**Response to Comments for the Federal Register Notice for Approval and Promulgation of
Air Quality Implementation Plans; Utah; Regional Haze State and Federal Implementation
Plans**

Docket No. EPA-R08-OAR-2015-0463

October 7, 2020

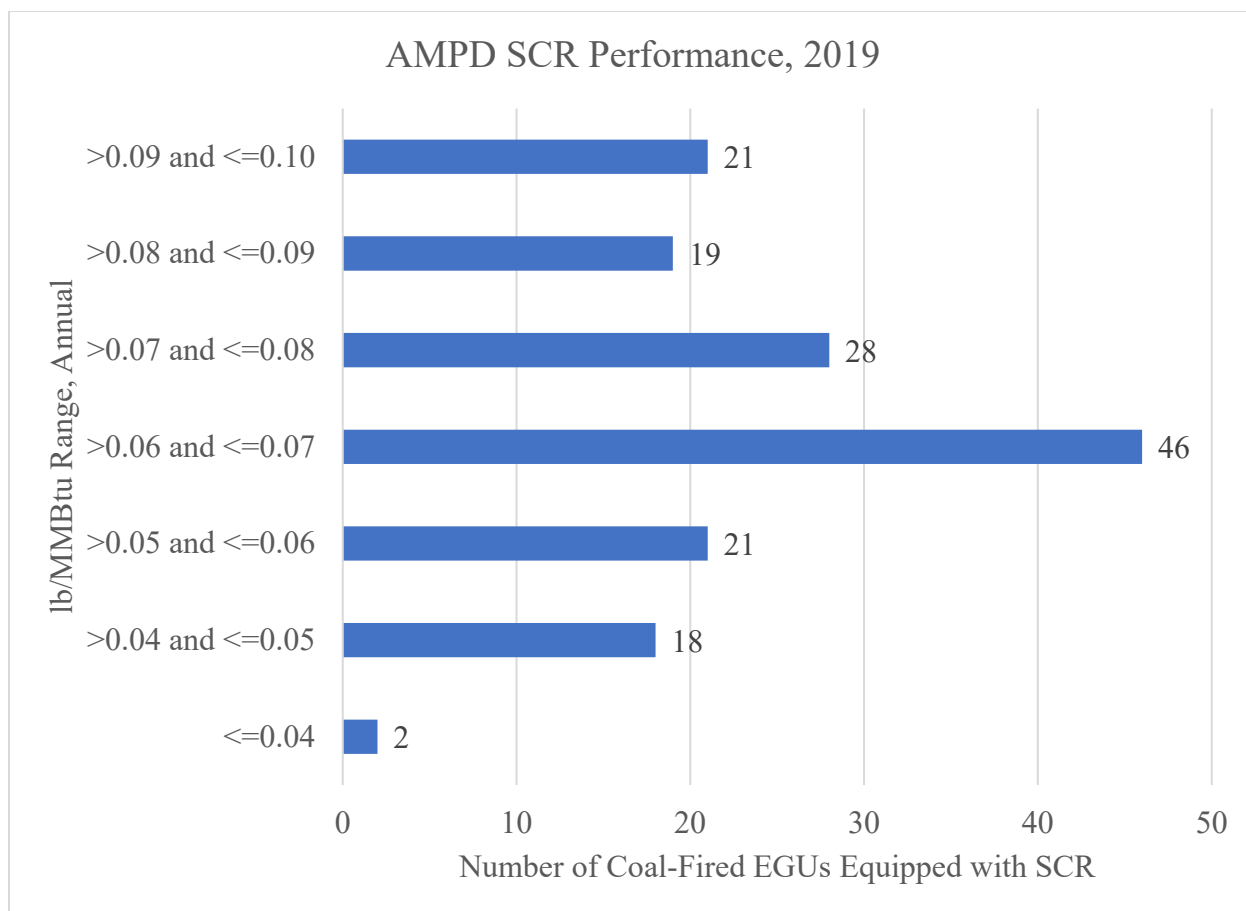
Comment: [Cons Orgs, p. 15-16] *The CAMx Modeling Assumes Lesser NO_x Emissions Reductions from BART than is Achievable.*

The CAMx modeling is flawed for the additional reason that it underestimates the emission reductions—and thus visibility benefits—achievable through the operation of SCR in the BART scenario. As described above [in the comment letter], EPA may approve a BART alternative only if EPA rationally determines that that the alternative would yield “greater reasonable progress” toward eliminating visibility impairment than implementation of BART. 40 C.F.R. § 51.308(e). In making that determination, EPA must compare the visibility improvement achievable through implementation of BART (the BART benchmark) to that achievable under the BART alternative. *See id.* § 51.308(e)(2)(i)(C)-(E), (3). The comparison of the two scenarios must rest on a rational assessment of the emissions rates achievable with the controls constituting “the best system of continuous emission control technology available” for the relevant source(s), i.e., the BART benchmark, and the emissions rates “achievable” with the controls contemplated under the BART alternative. *See id.* § 51.308(e)(2)(i)(C)-(D). EPA failed to conduct such a rational assessment for the Proposed Rule, instead relying on an obsolete and erroneous emission rate “achievable” for SCR.

lb/MMBtu on a 30-day rolling average, as approved by EPA four years ago in its FIP. However, there are several EGUs that have achieved NO_x emission rates of 0.04 lb/MMBtu or lower on an annual average basis. A review of recent emissions data from EPA's Air Markets Program Database shows that the following units have achieved annual average NO_x rates of 0.04 lb/MMBtu with SCR, including Jeffrey Energy Center Unit 1 in Kansas, Edgewater Unit 5 in Wisconsin, Gallatin Units 1 and 2 in Tennessee, Ghent Unit 4 in Kentucky, John W Turk Jr. Unit 1 in Arkansas, Dry Fork Unit 1 in Wyoming, Sandy Creek Unit 1 in Texas, and W A Parish Unit 7 in Texas.

Response: The EPA responds to this comment in the preamble to the final rule. The figure below supports that response.

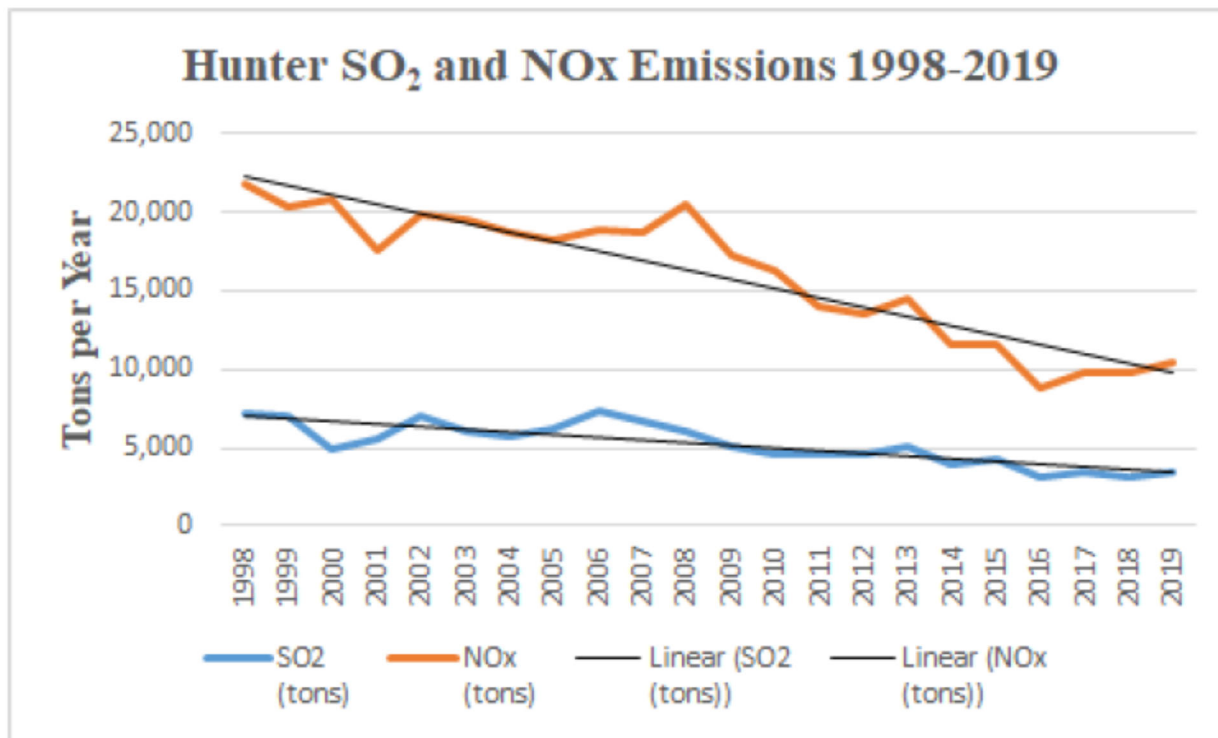
All 9 Class I Areas ⁶²	Utah’s BART Alternative	Utah’s Most Stringent NO _x (BART FIP)	MATS#2	MATS#1
# Days ≥ 0.5 dV impact	441	499	409	367
# Days ≥ 1.0 dV impact	258	264	217	186
Avg 98 th percentile delta-dV	2.39	2.25	1.93	1.69
Avg delta-dV All Days	0.28	0.29	0.23	0.20
3-yr 98 th percentile (24 th high)	2.33	2.18	1.88	1.63
3-yr 90 th percentile (110 th high)	0.81	0.82	0.69	0.60

In evaluating each of the visibility metrics evaluated by Utah in its 2015 BART alternative evaluation, Dr. Gray concludes that, “[e]xamination of ALL the visibility metrics leads to the same conclusion: Utah’s ‘Alternative to BART’ strategy would result in significantly *greater visibility impairment* in ALL modeled Class I areas than BART (MATS#1 or MATS#2). Visibility conditions would decline in Class I areas if the Utah’s BART Alternative scenario is adopted over either the MATS compliance scenario #1 or MATS compliance scenario #2, which are more realistic representations of emissions that would occur under the BART FIP than the Most Stringent NO_x scenario.” [fn omitted] It is very important to note that Dr. Gray did not change Utah’s modeling of Carbon Units 1 and 2’s SO₂ emissions from the 2012-2013 to the more representative 2001-2003 time period, even though Carbon Plant’s higher SO₂ emissions in 2012-2013 were atypical of historical SO₂ emissions and that such emissions were not surplus to the lower SO₂ emissions of the regional haze baseline. [fn omitted] Regardless, Dr. Gray concluded that Utah’s BART Alternative scenario will result in significantly greater visibility impairment at every modeled Class I area for every metric used.

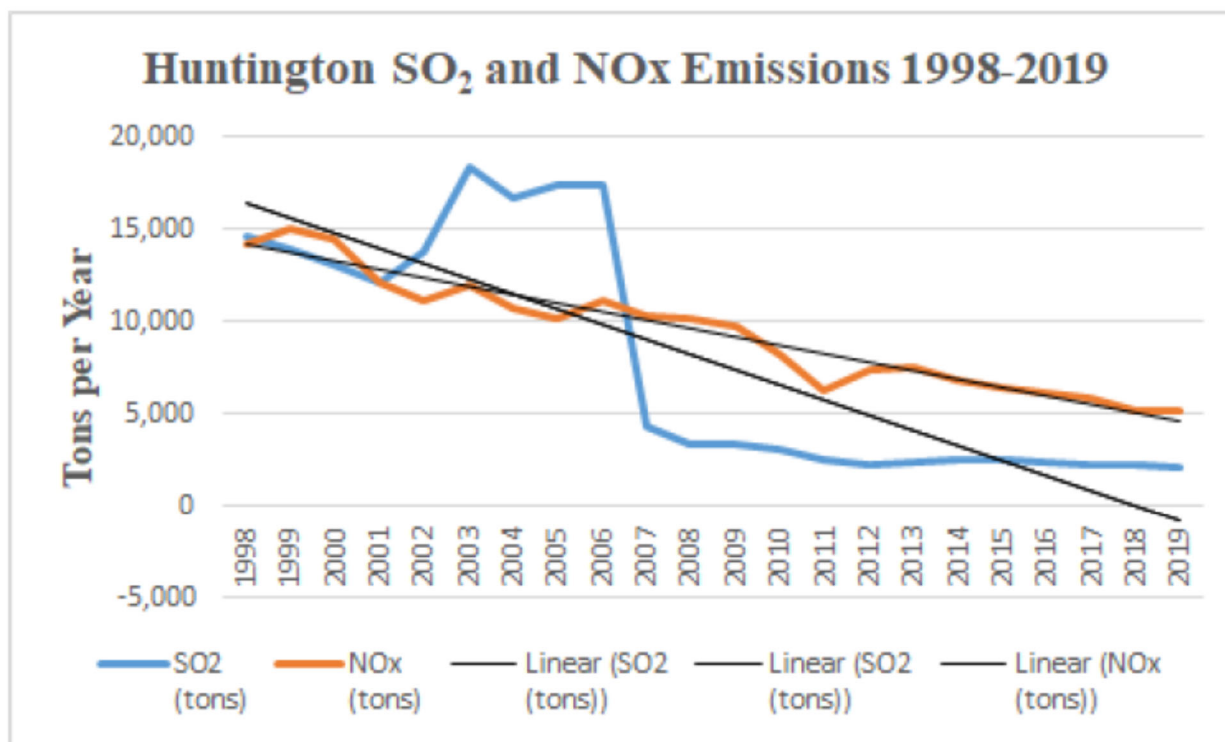
Evidence from EPA's Acid Rain Database (found on EPA's publicly available Air Markets Program Data website) demonstrates that emissions from the Hunter and Huntington Power Plants have greatly decreased since 1998, about the time the regional haze program began. In 1998, the Hunter Plant's emissions of sulfur dioxide ("SO₂") were 7,226 tons per year, decreasing 51% to 3,546 tons per year of SO₂ by 2019. Likewise, the Hunter Plant's emissions of NO_x were 21,841 tons per year in 1997, decreasing 52% to 10,514 tons per year of NO_x by 2019. The graph below, based on emissions data from EPA's Acid Rain Database, shows SO₂ and NO_x emissions from the Hunter Plant between 1998 and 2019. Despite claims by critics to the contrary, this graph clearly shows emissions have greatly decreased at the Hunter plant.

The Huntington power plant has seen similar emissions decreases. In 1998, the Huntington Plant's emissions of SO₂ were 14,567 tons per year, decreasing 85% to 2,144 tons per year of SO₂ by 2019. Likewise, the Huntington Plant's emissions of NO_x were 14,122 tons per year in 1997, decreasing 63% to 5,206 tons per year of NO_x by 2019. The graph below, based on emissions data from EPA's Acid Rain Database, represents SO₂ and NO_x emissions from the Huntington Plant between 1998 and 2019.

As the graphs above demonstrate, Utah’s air quality program is working, and the Hunter and Huntington Plants’ impact on air quality in the general area is improving. It is against this backdrop that EPA’s Proposed Rule should be considered.

Response: We acknowledge the emission reductions cited by the commenter that have occurred at the Hunter and Huntington power plants. However, this information is not pertinent to EPA’s approval of Utah’s NO_x BART Alternative which relies on the two-prong modeling test described at 40 CFR 51.308(e)(3)(i) and (ii) rather than the clear weight-of-evidence test described at 40 CFR 51.308(e)(2)(i)(E).

Figure 1a – IMPROVE Light Extinction Measurements (Canyonlands)

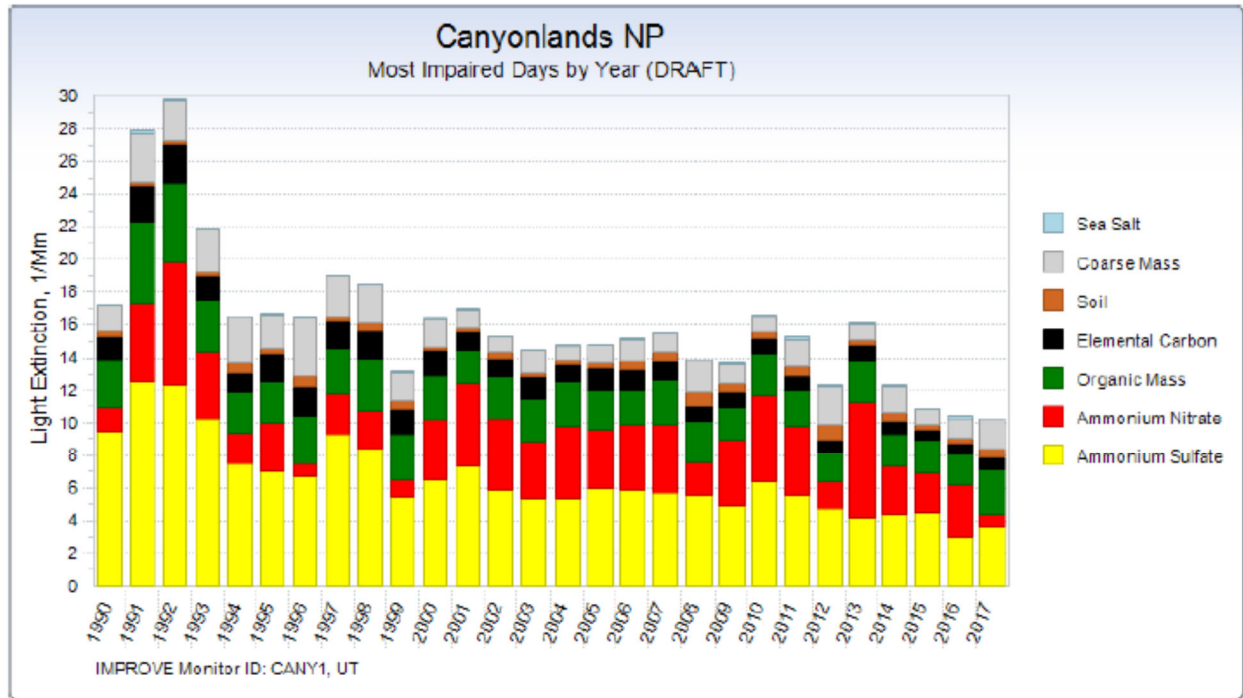
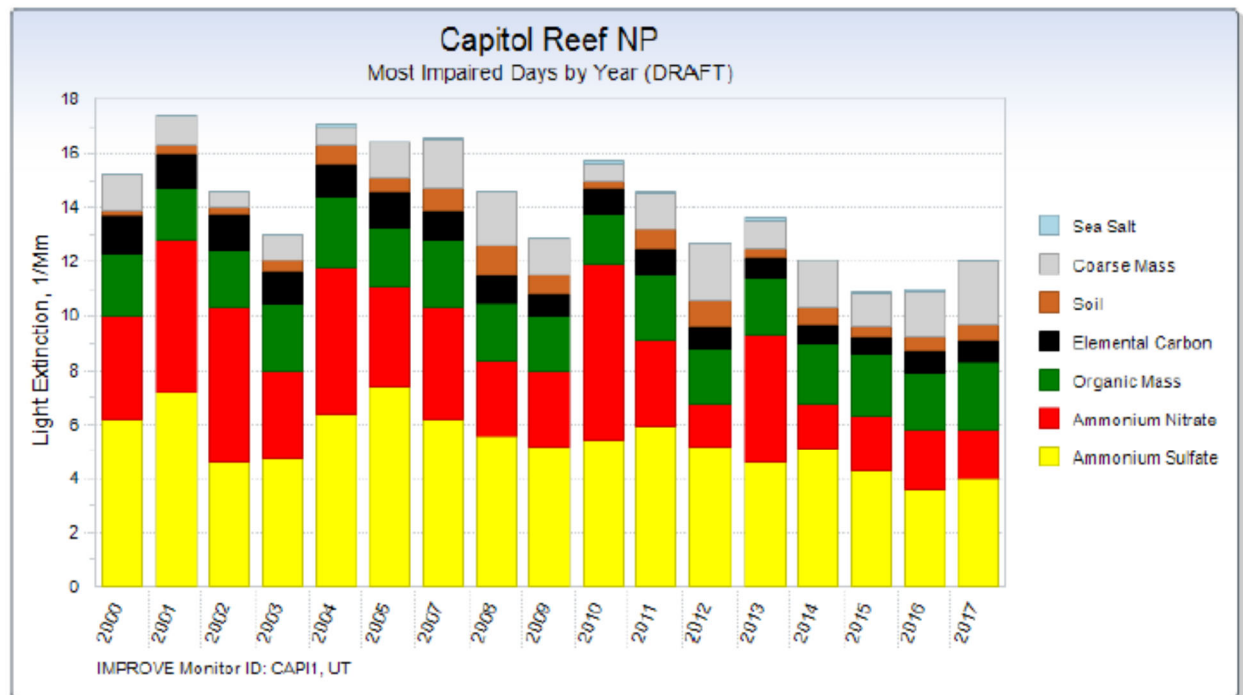
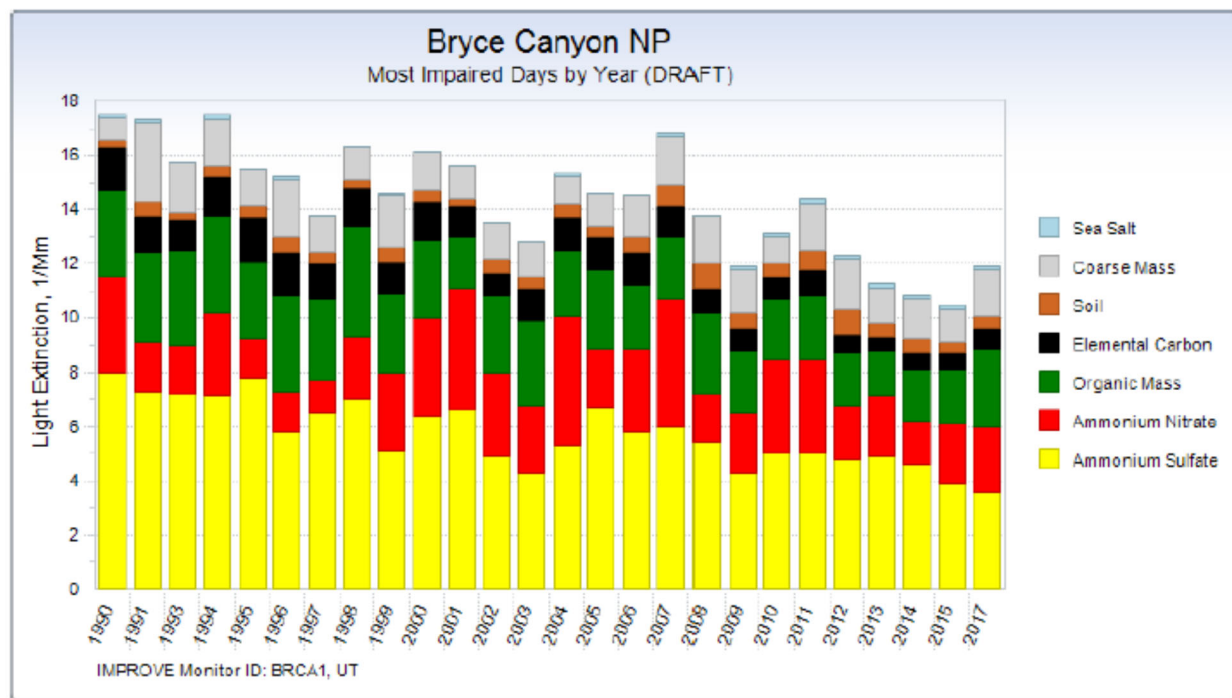
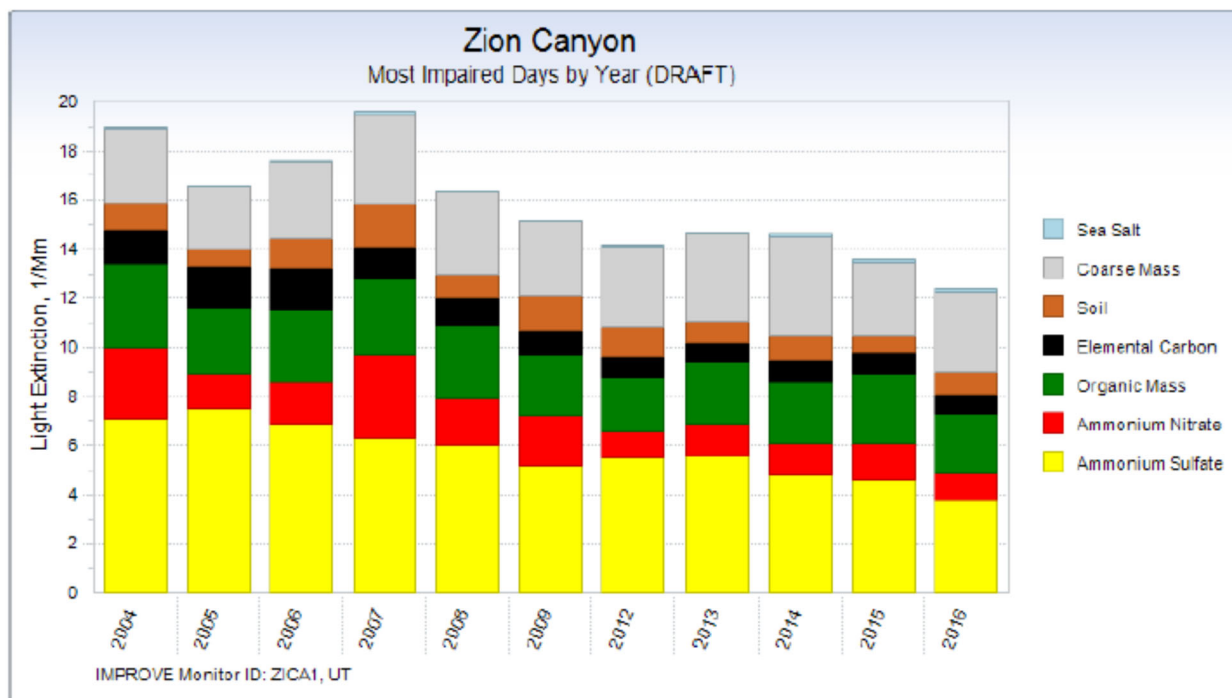
In the Utah staff review of the proposed SIP amendments (Reference 8 [omitted]), a graph is presented showing the seasonal variability of nitrate levels at Canyonlands National Park (See Reference 8 [omitted], Figure 4). Overlaid on this chart is a depiction of park visitation, showing higher visitation during the summer and less visitation during the winter. Nitrate concentrations are also generally higher during the winter. While the presentation is factual, the implication of this figure is that Utah considers the visitor experience at Canyonlands during the winter months to be less important, and as such, NO_x emissions controls to reduce nitrate levels during the winter are viewed by Utah as unimportant and/or unnecessary.

The above data demonstrate that NO_x emissions and the resulting nitrate levels are important contributors to existing visibility impairment at Utah’s National Parks. It is a mistake to abandon improved emissions controls at NO_x emission sources that contribute to nitrate levels at Utah’s parks. Utah’s Regional Haze emissions control strategy needs to address large NO_x emission sources such as PacifiCorp’s Hunter and Huntington Plants. Abandoning NO_x emission controls, as proposed in the Utah Regional Haze SIP amendments, only sets back the goal of improving visibility in Utah’s parks. Visibility improvements only occur by targeting emission reductions for all precursor pollutants and not just SO₂.

Response: We disagree with this comment. We explain elsewhere in this RTC document and preambles to the proposed and final rules why the modeling protocol was reasonable and appropriate for this action, including that the model analyzes the best and worst 20% of days consistent with the BART-alternative provisions of the Regional Haze Rule. Additionally, the commenter has not provided evidence to support a conclusion that use of the most impaired days would have changed the outcome of the two-prong test used to assess whether the Utah NO_x BART Alternative achieves greater reasonable progress.

Regarding the importance of NO_x reductions relative to SO₂ reductions in addressing visibility impairment, we do not dispute that NO_x reductions may yield meaningful visibility improvements. Yet, the IMPROVE data provided by the commenter for the most impaired days shows that sulfate is almost always a larger contributor to visibility impairment at the Class I areas in question. Utah has successfully demonstrated that substituting SO₂ reductions for NO_x reductions under the Utah NO_x BART Alternative achieves greater reasonable progress in accordance with 40 CFR 51.308(e)(2) and (3).
